# Supporting Materials for comment #99

## Comment #99

# 50GE Baseline (nicholl\_3cd\_01a\_0516.pdf)

## 50GbE - Alignment marker mapping to FEC lane

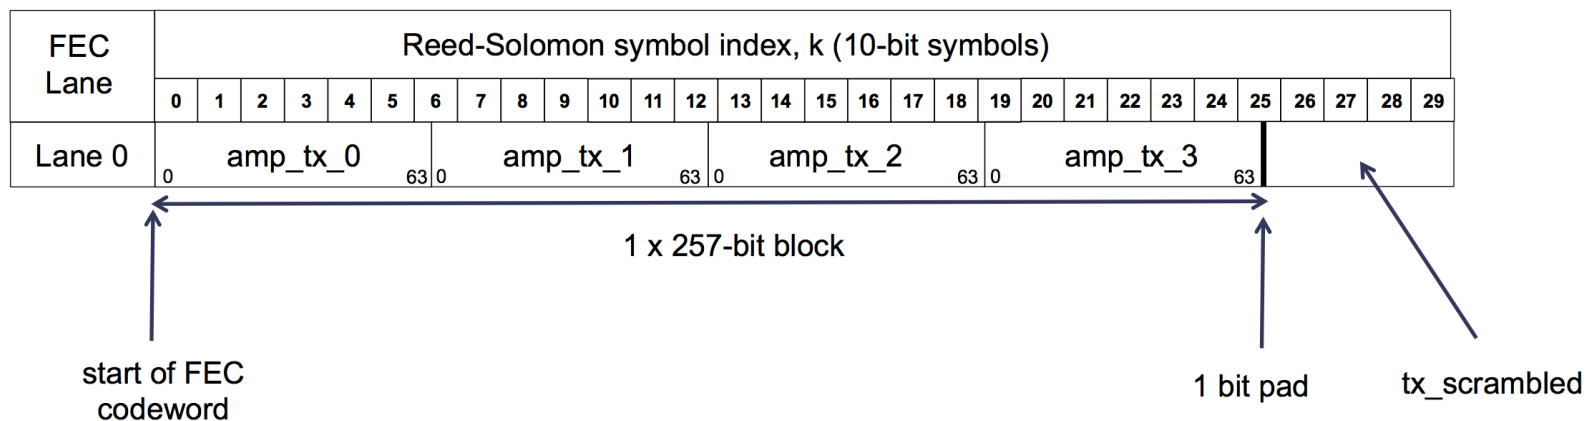
Shift tx\_am\_sf to be the first nibble of the UP0 for lane 0. Make the 2nd nibble of UP0 for lane 0 be it's inverse. Then 802.3cd can insert it in the single lane implementations in the same "spot".

Only a 1bit pad. Where are 3bit of degrade indication going to go?

- Replace UP0 of all AM0 lanes with 4b degrade signal field (and it's inverse)
  - Provides a common location for all PHYs to look for degrade signaling. Since all PHYs have at least 1 PCS lane, they all would look at bits 37:33 of PCS lane 0 for degrade info.
  - 200G has 4 – 257b AM blocks with a 68b pad
  - 400G has 8 – 257b AM blocks with 136b pad
  - 50G will have 1 – 257b AM block
- Would also provide a location that 25GE could be enhanced to place the information at.
- Would only work for PHYs that don't provide BIP, but the current solution also requires the lack of BIP to provide a Pad space at the end of the AM TC blocks.
- Would limit signally to a 4b field, while current location would allow for expansion beyond 4b.
